Access Compliance Report

Public Rights-of-Way

(Pedestrian Signals)

Intersection ID: N/A	Main Street:	Cross Street: N/A	Location: N/A
ADA ID: 81ACFA72E71A	Signal Type: Two Push Buttons-Non APS	Overall Compliance: No	Severity Score: BTN 1:N/A BTN 2: N/A No BTN: N/A
Codes/Mitigation Info/Possible Solution		Field Measurements/Component Compliance

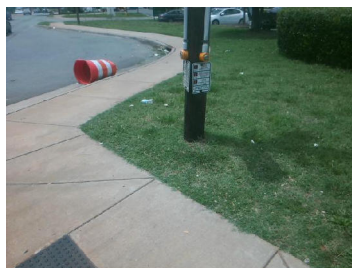
Surveyor Notes: TEXT HT 7/16

PROW/ADA: R410.6, R209.1, TMUTCD 4e.08, R404.2, R406.2, R404.7.3

Yes	B 1 Clear Xing Direction?	ClearlyMarked	Yes	B 2 Clear Xing Direction?	ClearlyMarked
	B 1 Crossing Direction	To S		B 2 Crossing Direction	To NE
Yes	B 1 DistanceTo XWalk (in)	58.0	Yes	B 2 DistanceTo XWalk (in)	26.0
No	B 1 DistanceTo Curb (in)	94.0	No	B 2 DistanceTo Curb (in)	88.0
Yes	B 1 Diameter (in)	2.0	Yes	B 2 Diameter (in)	2.0

Possible Solutions: Replace Signal Push Button With APS Button on New Post. Remove & Replace Sign.
